ARKANSAS NUCLEAR ONE, UNIT 1

AMENDMENT TO FACILITY OPERATING LICENSE

Amendment No. 105
License No. DPR-51

SAFETY EVALUATION BY THE OFFICE OF NUCLEAR REACTOR REGULATION
SUPPORTING AMENDMENT NO.105 TO FACILITY OPERATING LICENSE NO. DPR-51
ARKANSAS POWER AND LIGHT COMPANY
ARKANSAS NUCLEAR ONE, UNIT NO. 1
DOCKET NO. 50-313

Figure 3.5.2-3D

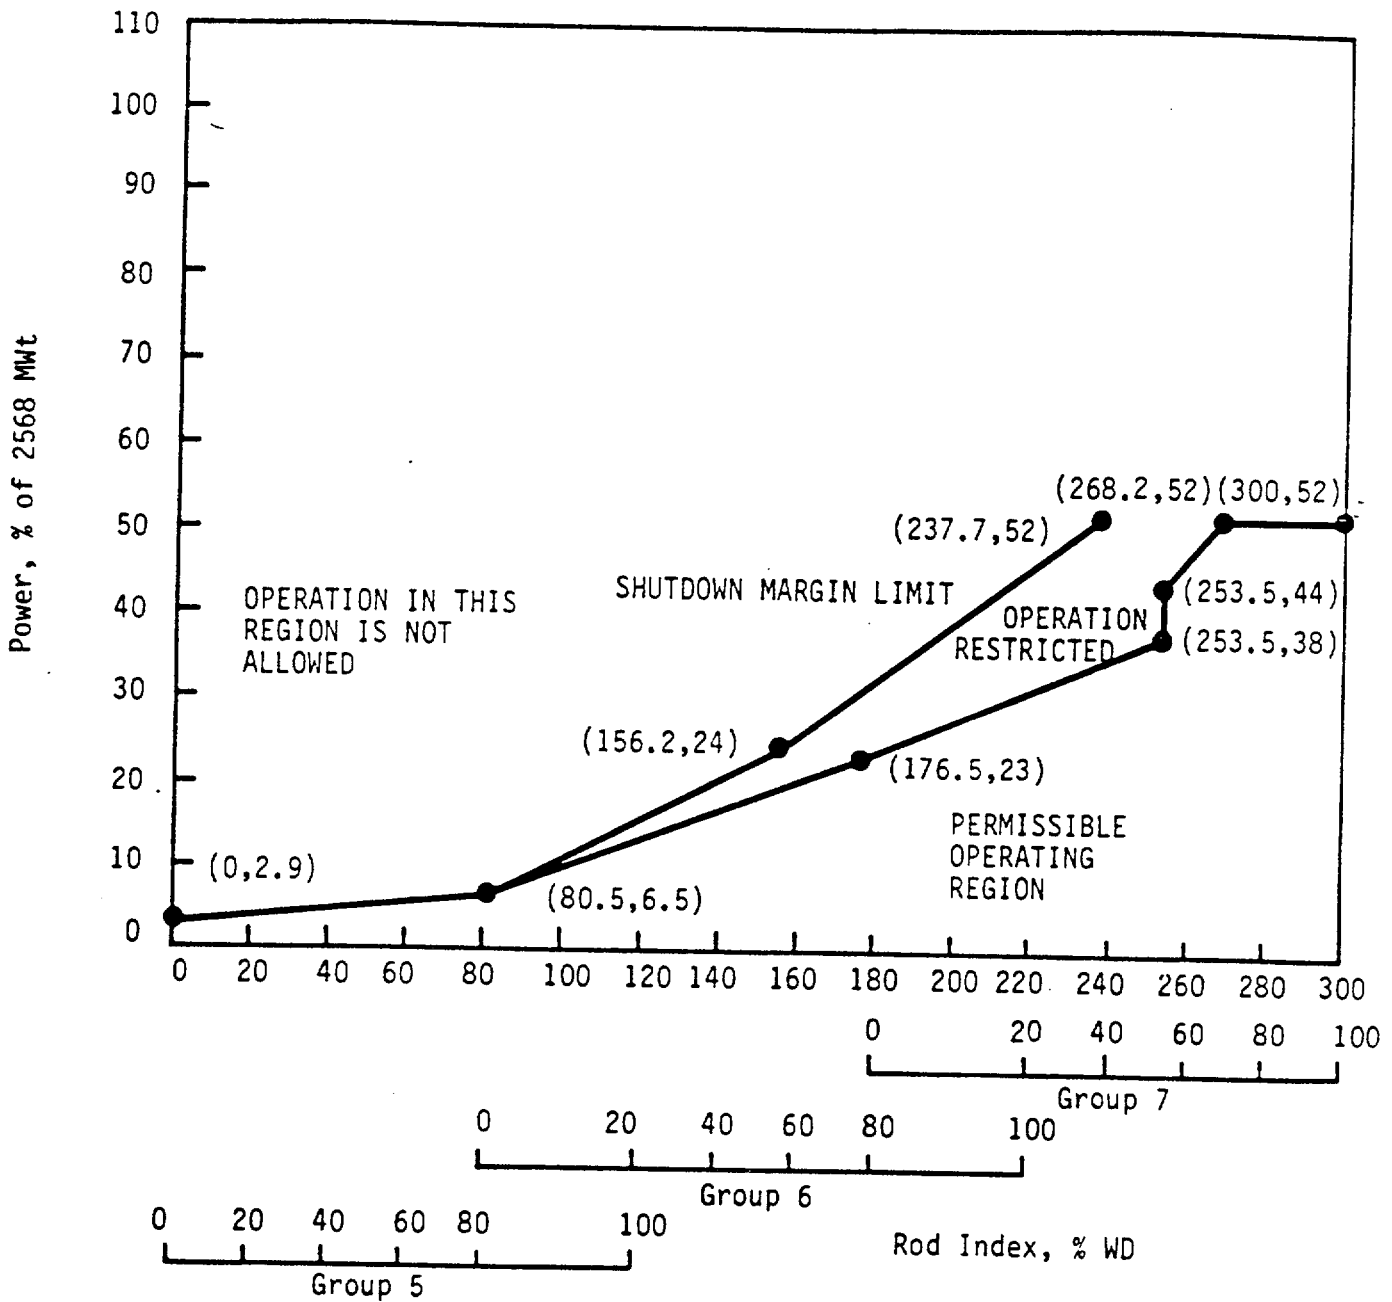
3. Except for physics tests or exercising control rods, (a) the control rod withdrawal limits are specified on Figures 3.5.2-1(A-D), 3.5.2-2(A-D), and 3.5.2-3(A-D) for 4, 3 and 2 pump operation respectively; and (b) the axial power shaping control rod withdrawal limits are specified on Figure 3.5.2-6(A-D). If any of these control rod position limits are exceeded, corrective measures shall be taken immediately to achieve an acceptable control rod position. Acceptable control rod positions shall be attained within 4 hours.

2. TS 3.5.2.4.1 Quadrant Tilt
The power level cutoff requirement has been deleted.
3. TS 3.5.2.5.3 Control Rod Positions
New control rod insertion limits are provided for 4, 3 and 2 pump operation, as well as a function of burnup interval. APSR limits are also provided as a function of burnup interval.

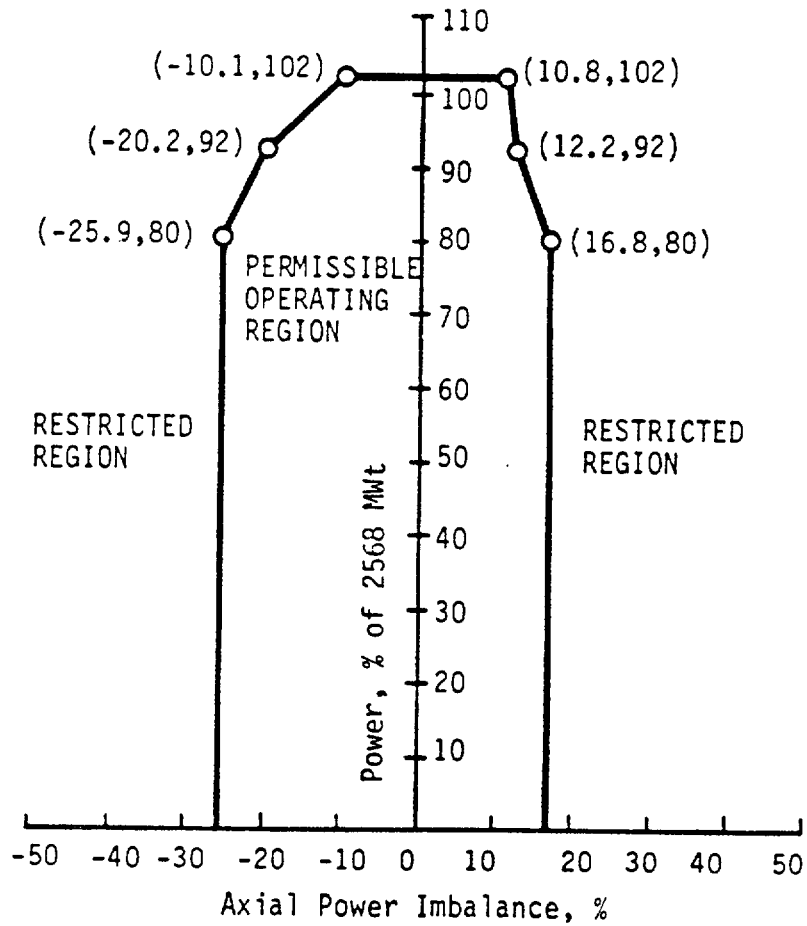
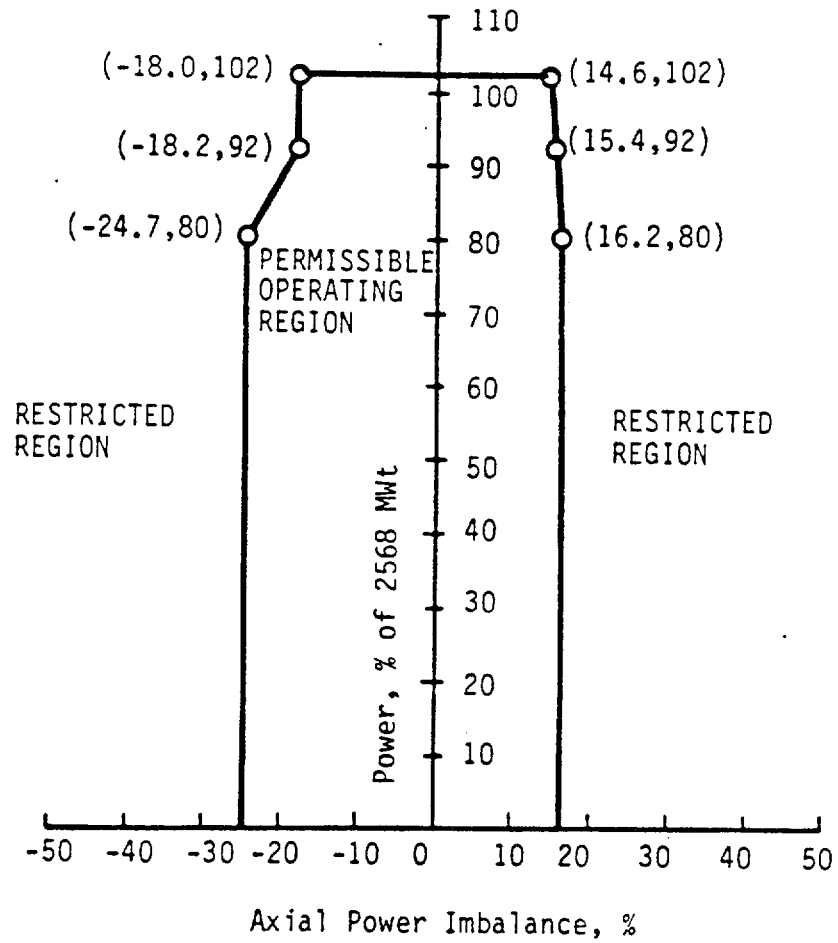
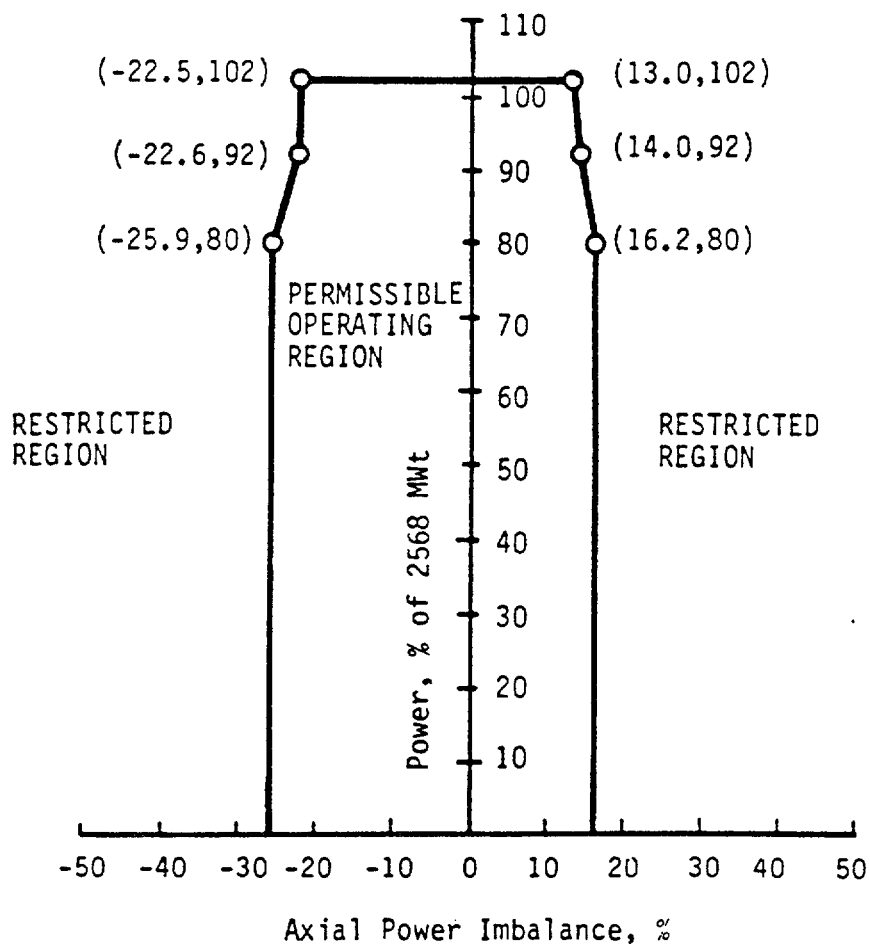
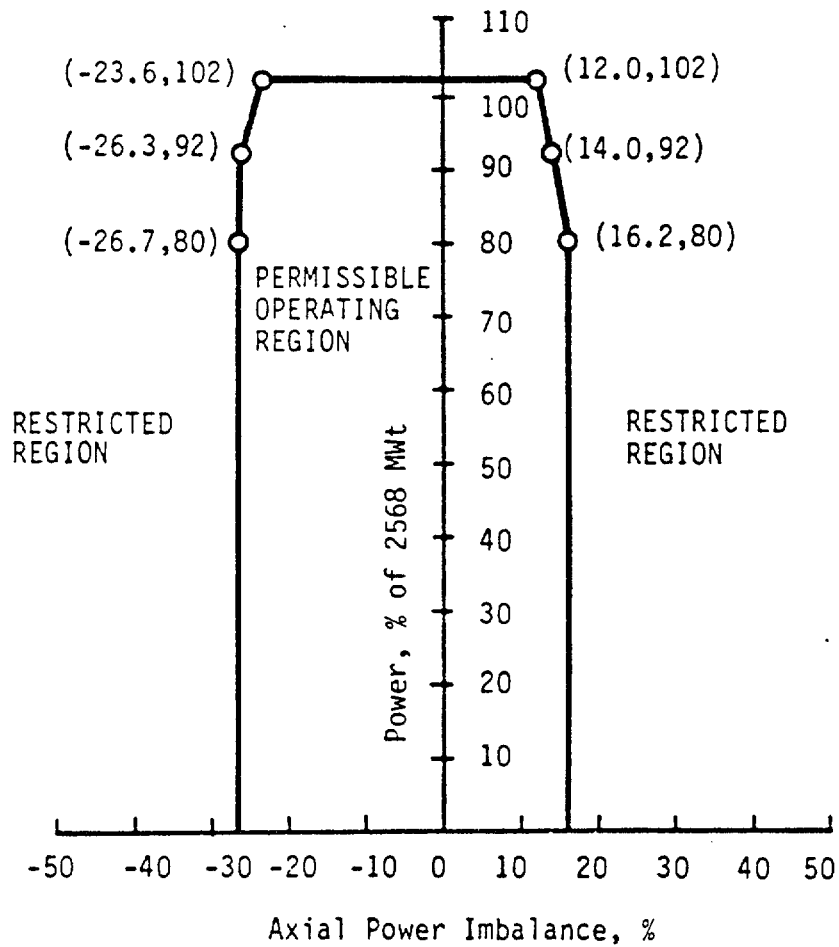
- 3.5.2.6 Reactor Power Imbalance shall be monitored on a frequency not to exceed 2 hours during power operation above 40% rated power. Except for physics tests, imbalance shall be maintained within the envelope defined by Figure 3.5.2-4(A-D). If the imbalance is not within the envelope defined by Figure 3.5.2-4(A-D), corrective measures shall be taken to achieve an acceptable imbalance. If an acceptable imbalance is not achieved within 4 hours, reactor power shall be reduced until imbalance limits are met.

4. TS 3.5.2.5.4 Control Rod Positions
The power level cutoff requirements have been deleted.
5. TS 3.5.2.6 Reactor Power Imbalance
Power-imbalance curves for Cycle 8 as a function of burnup interval are added.

Figure 3.5.2-5

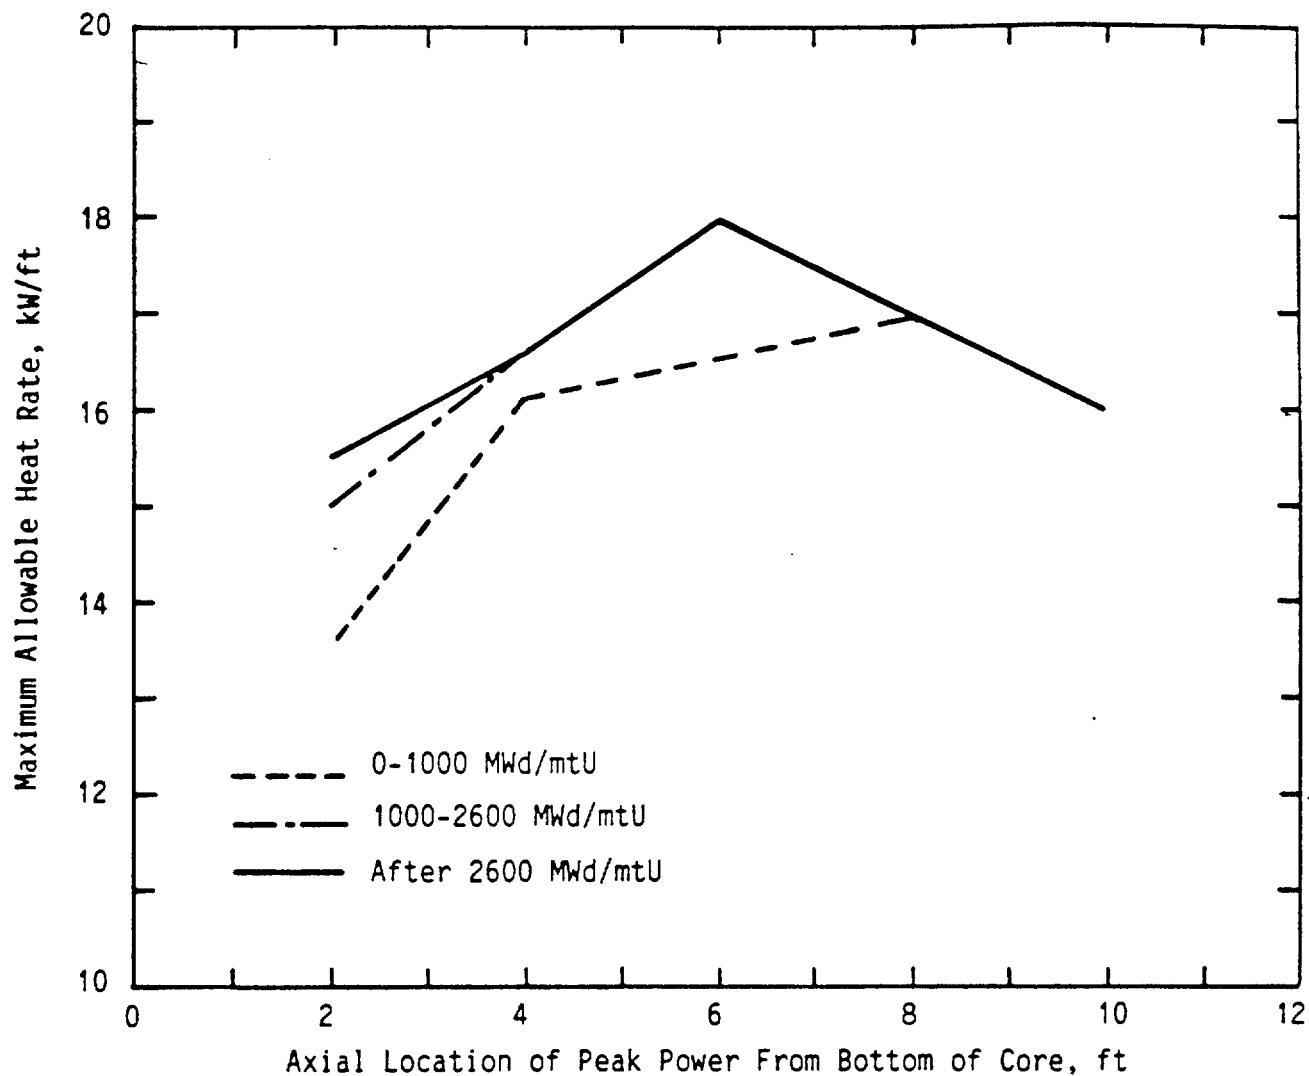
6. TS 3.5
The basis has been modified to include the Cycle 8 power-imbalance curve and the maximum allowed linear heat rate as a function of burnup interval that meets the FAC on ECCS.
